**Lee County, Florida
DEPARTMENT OF COMMUNITY DEVELOPMENT
ZONING SECTION
STAFF REPORT**

CASE NUMBER: DCI2022-00059
TYPE OF CASE: Major Planned Development
CASE NAME: Daniels Town Square MPD
TOTAL ACREAGE: 61.26 +/- acres
SUFFICIENCY DATE: July 12, 2024
HEARING EXAMINER DATE: September 26, 2024

MASTER CONCEPT PLAN FOR
DANIELS TOWN SQUARE
CLIENT:
BISON PROPERTY HOLDINGS, LLC

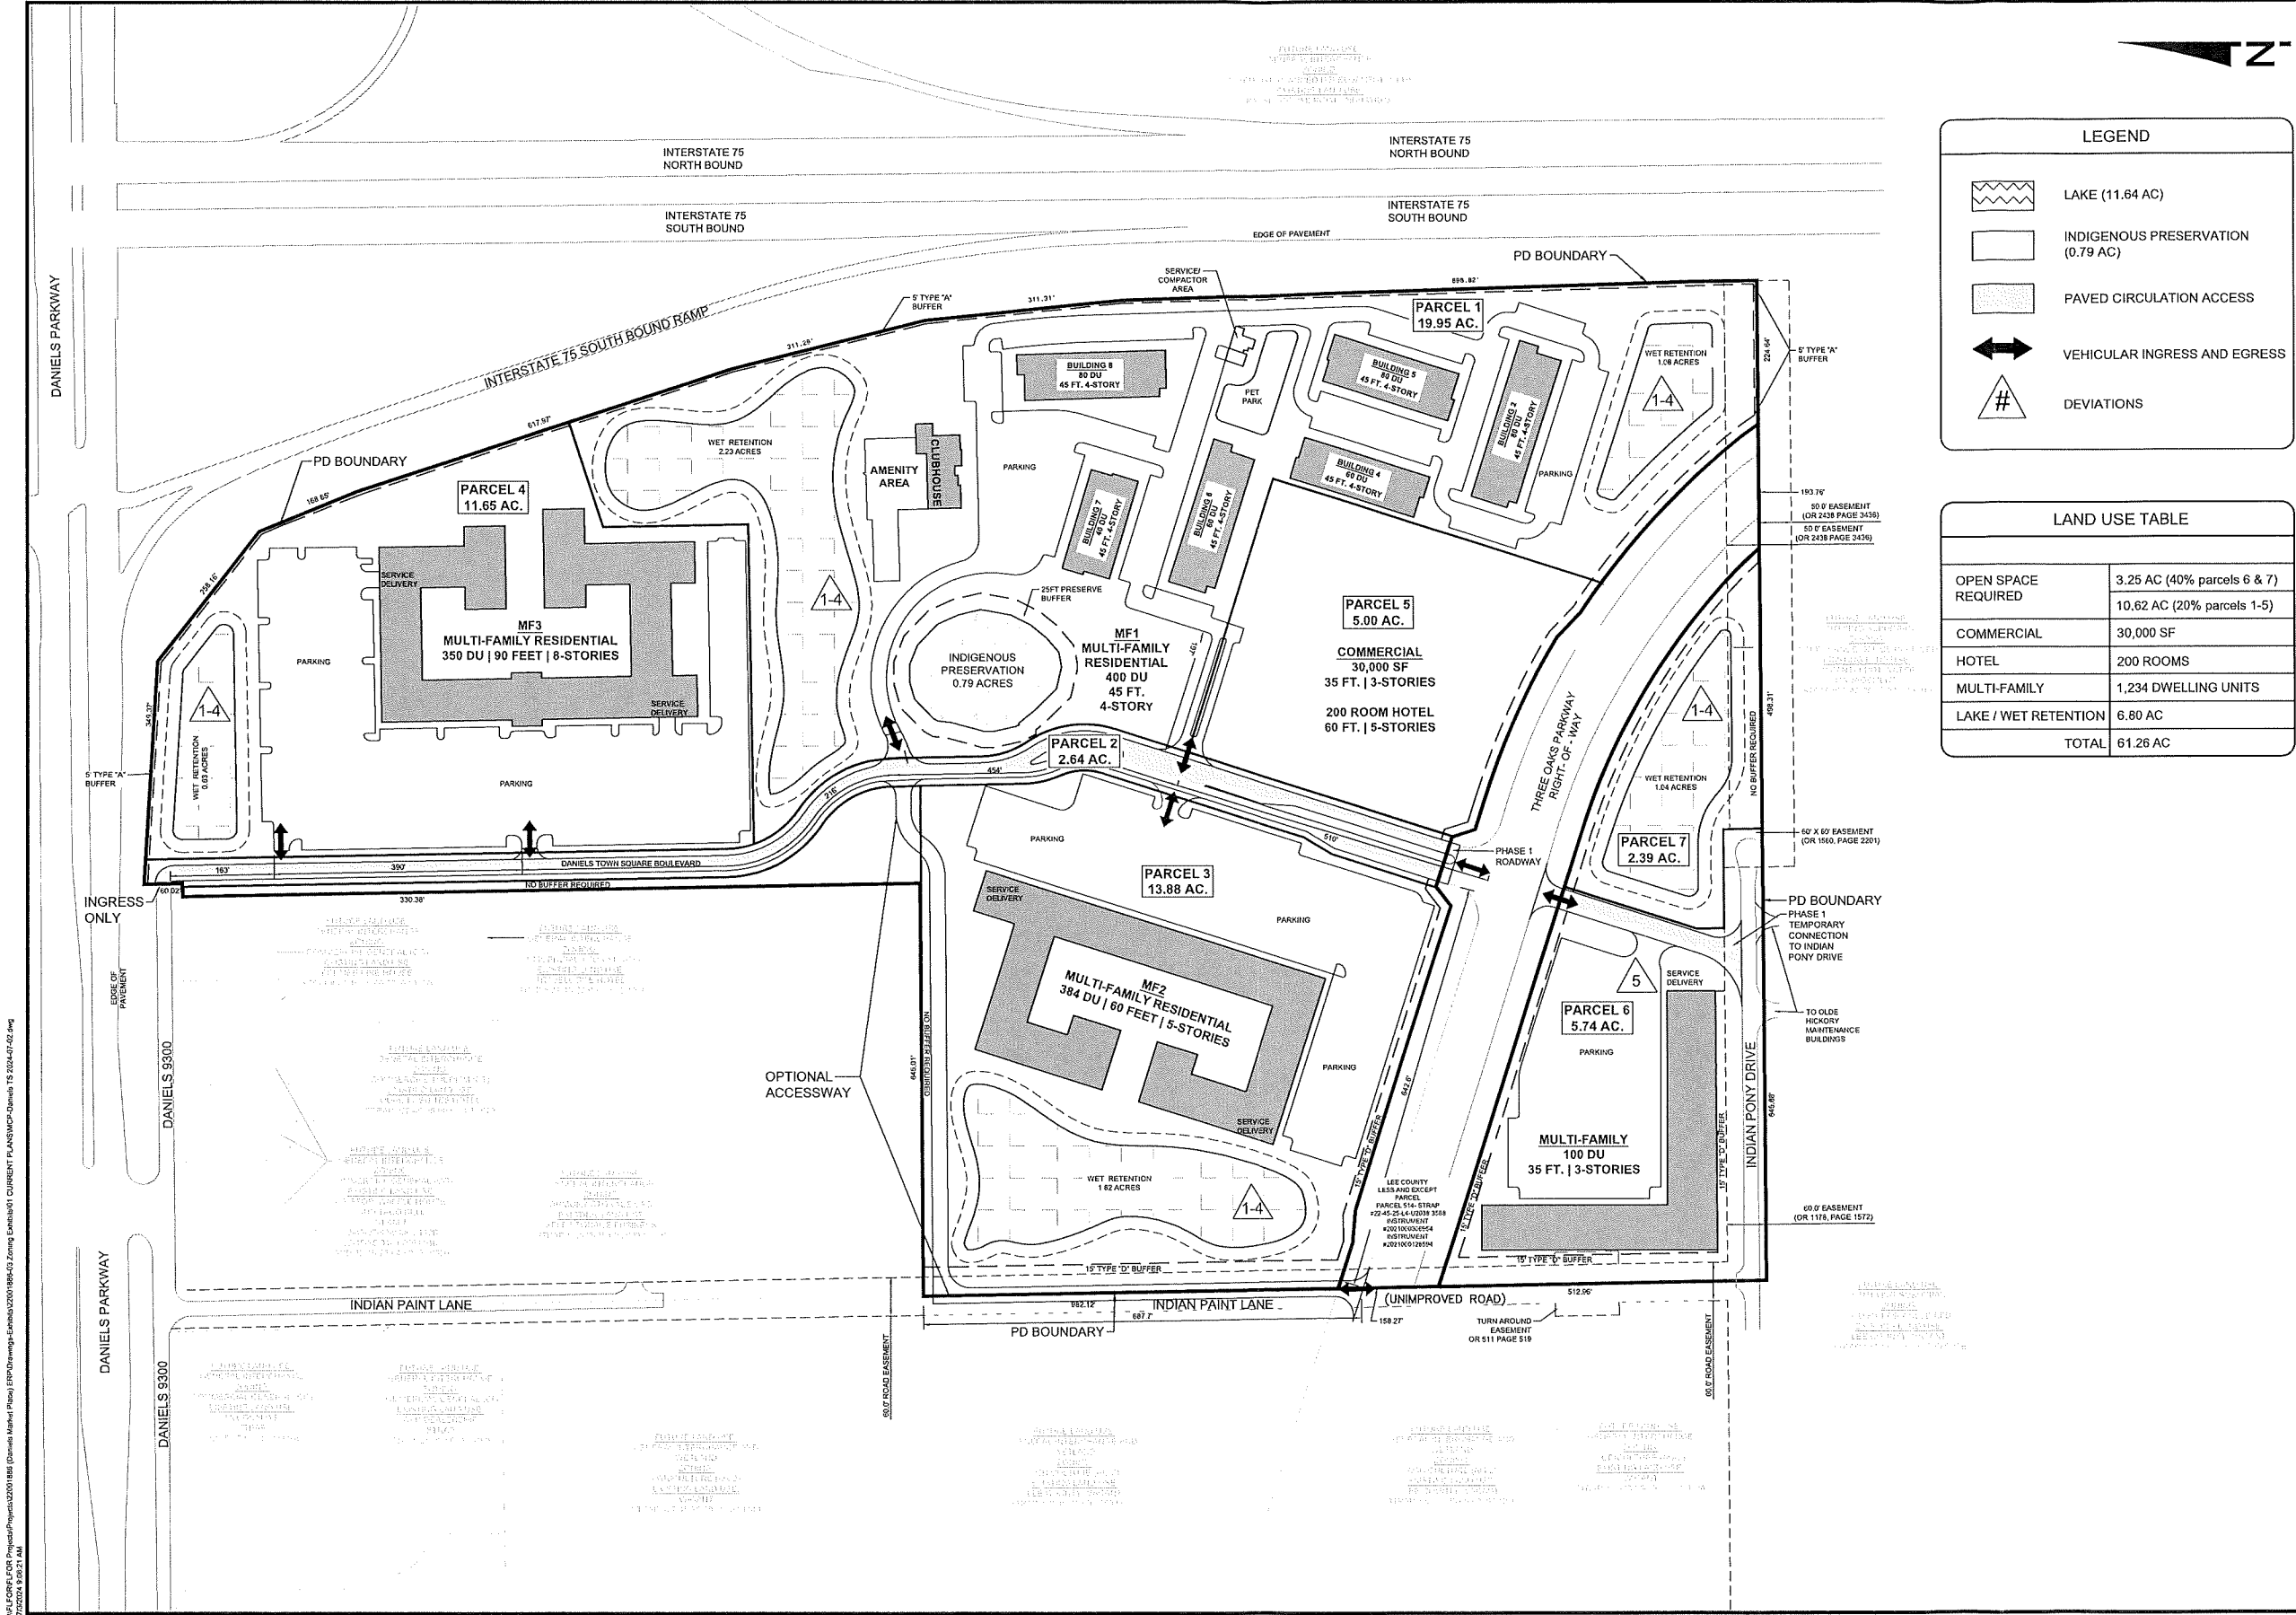
1. The applicant submitted Letters of Availability for potable water and sanitary sewer that provide analysis for 1,590 single-family dwelling units. The applicant must provide a revised letter from Lee County Utilities analyzing the correct development parameters for the request.

2. The South Trail Fire District provided a Letter of Availability stating that they would be challenged to provide adequate fire protection and non-transport Advanced Life Support Services to the proposed development without making enhancements to their current service-delivery model, specifically an additional fire/EMS substation. South Trail has express interest in having the applicant donate land within the development to construct a future fire station. The Schedule of Uses proposed by the applicant does not include EMS, fire or sheriff's station. The applicant must provide a revised letter or additional documentation to demonstrate compliance with the Lee Plan.

The applicant has requested deviations from the required lake bank slope requirement of 6:1 per LDC Section 10-329(d)(4)(a) to allow 4:1 lake bank slopes and to replace herbaceous littorals required per LDC Section 10-418(2) with wetland trees. These deviations are required because the subject property is located within 10,000 feet of Southwest Florida International Airport. The requested deviations reduce the migratory bird habitat, thereby decreasing the potential for hazardous air navigation situations. Since the applicant is eliminating the planted littoral shelves on the lake, staff has concerns regarding water quality within the watershed. **Lee Plan Policy 125.1.2** states new development and additions to existing development must not degrade surface and ground water quality. If the development has the potential of lowering existing water quality below state and federal water quality standards, Lee Plan Policy 125.1.4 states that standardized appropriate monitoring data must be provided. Natural Resources has provided a staff memorandum explaining the need for a staff recommended water quality monitoring condition (Attachment C & K).

Deviation (2) seeks relief from LDC Section 10-418(2)a which requires planted littoral shelves (PLS) shoreline length to be calculated at 25 percent of the total linear feet of the lake at control elevation; to eliminate this requirement as a recommended action to minimize wildlife hazards within the 10,000-foot Hazardous Wildlife Zone criteria for airport operations and in accordance with the Federal Aviation Administration Advisory Circular 150/5200-33C.

Deviation (3) seeks relief from LDC Section 10-418(2)c to eliminate the required 20-foot-wide planted littoral shelf extending waterward of the control elevation at a depth no greater than two feet below the control elevation to minimize the potential for bird attractants.

Deviation (4) seeks relief from LDC Section 10-418(2)d.3., which allows native wetland trees to be substituted for up to 25 percent of the total herbaceous plants required, to allow for native wetland trees to be substituted for 100 percent of the required herbaceous plants.

Deviation (5) seeks relief from Section 10-291(3) which requires residential development of more than five acres to provide more than one means of ingress and egress for the development, to allow for one means of ingress/egress for Parcel 6.

Staff recommends **APPROVAL** of the applicant's request, with the Conditions found in Attachment C. The applicant seeks five deviations from Land Development Code (LDC) requirements regarding lake design in proximity to the airport operations to the southeast and a single access to the southern parcel as shown on the MCP. Staff recommends approval of the deviations with conditions.

1. The development of this project must be consistent with one-page Master Concept Plan (MCP) entitled “Daniels Town Square”, prepared by Atwell, date stamped July 3, 2024, except as modified by the conditions below. This development must comply with all requirements of the Lee County LDC at the time of local development order, except as may be granted by deviation as part of this planned development. If changes to the MCP, conditions, or deviations are subsequently pursued, appropriate approvals will be necessary.
